# The Design and Alignment of P2

Submitted by The  
Conservancy Association to  
Panel of PLW subcom, LegCo

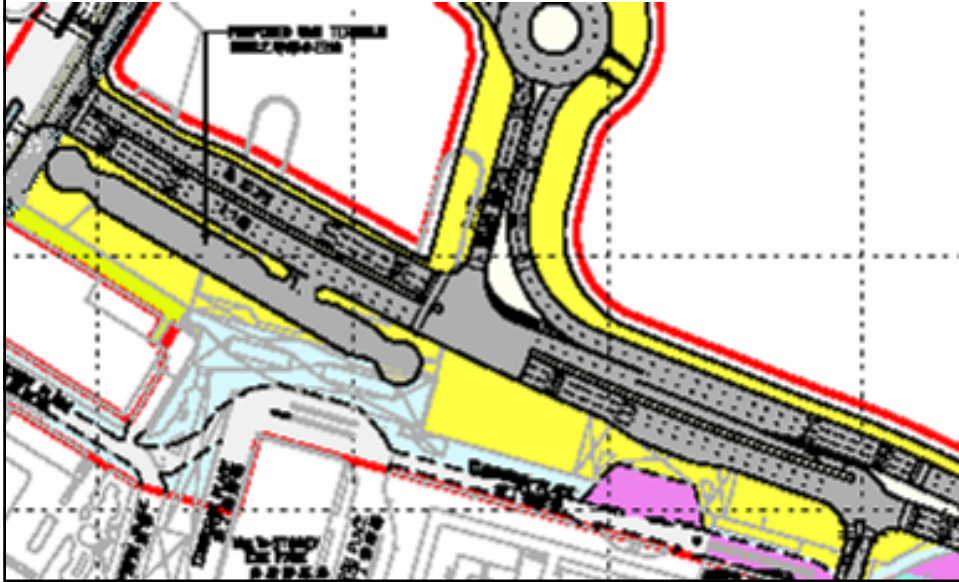
However, along the short section of concern (i.e., from Man Yiu Street to D7, there is also a P1 (2 x 2 lanes) from Man Yiu Street to D2 to share the traffic load. A total of 10 lanes (in 2 directions) in this short session to meet with this traffic demand (not to mention the future C&W Bypass) is too excessive. From D2 to D7, there are 6 to 8 lanes; it is again excessive.

The sections that pass through old star ferry pier and the existing Queen's Pier are 6 to 8 lanes which is much more than 2 x 2 lanes as specified in TD's paper. This section can certainly be narrowed down.

- Furthermore, P2 is designed to be a district distributor similar to Nathan Road, providing accesses to various points on-route; the design traffic speed should be no more than 50 kilometer per hour (kph); there is no need to have a wide dual carriageway; a narrow central divider is suffice for safety consideration;

- There is no need to put a passing pocket in front of the City Hall which the existing Queen's Pier stands.

In brief, there are ample room to streamline the design of P2 road, in particular, at the concerned section. With these streamlining, it is possible to avoid colliding into the existing QP site.
